Proposed Residential Development – Bricket Wood Sports And Country Club, Paintball Site & Bricket Lodge, Lye Lane, Bricket Wood, AL2 3TF

Technical Note

Prepared on behalf of JK Rudkin Builders Limited

June 2023

Drawing Number: 23051/002
Scale: As Shown @ A1
Revision: A

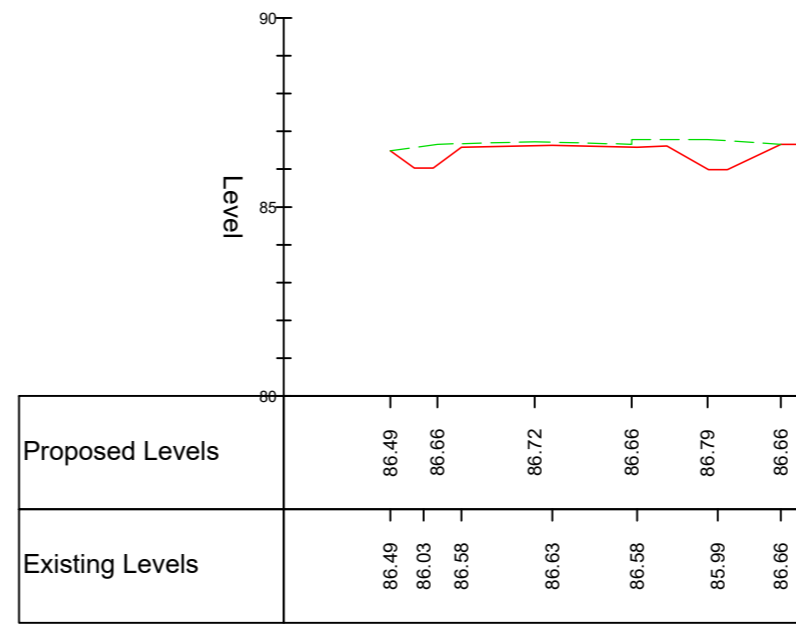
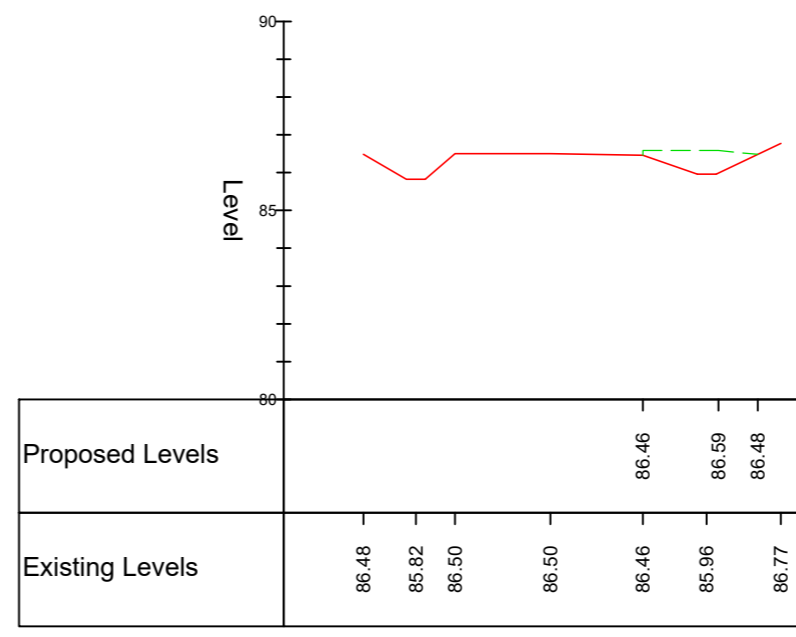
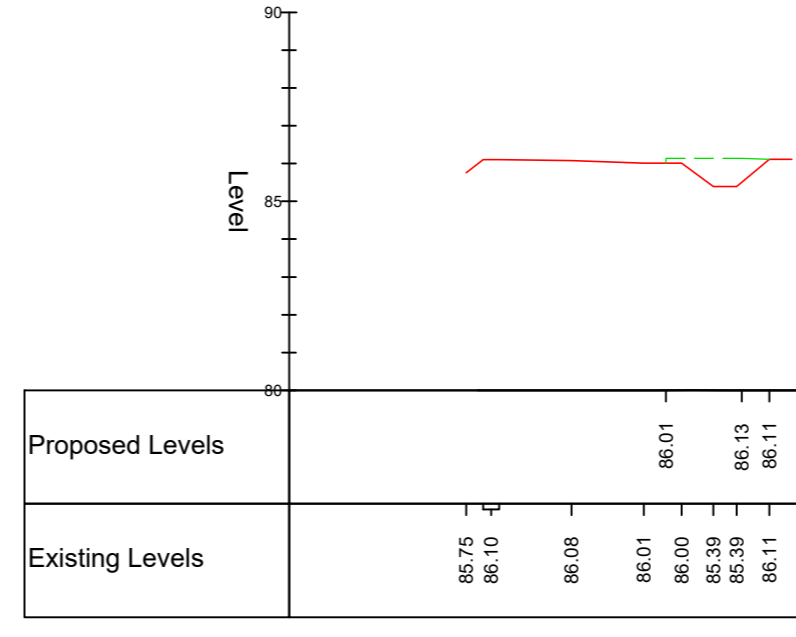
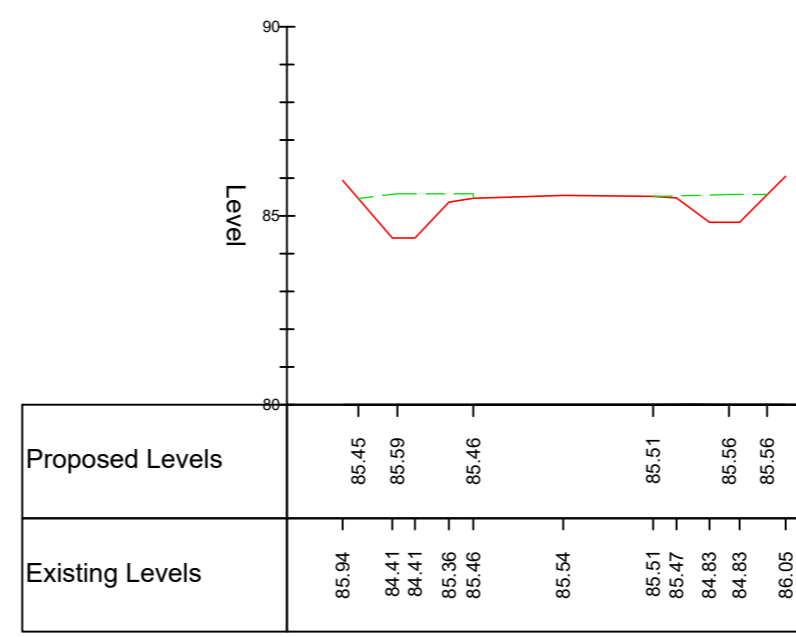
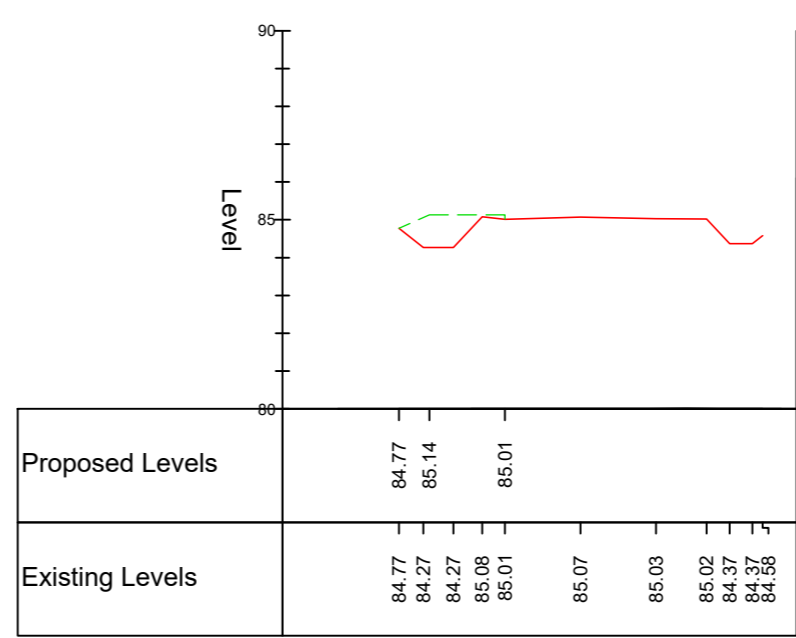
As the fill material is proposed to be permeable, any trees within the proposed verge will likely be retained. Drawing No. 23051 / 002, attached at Appendix 4, provides example cross sections of the proposed footway which will be explored further at the Detailed Design stage.
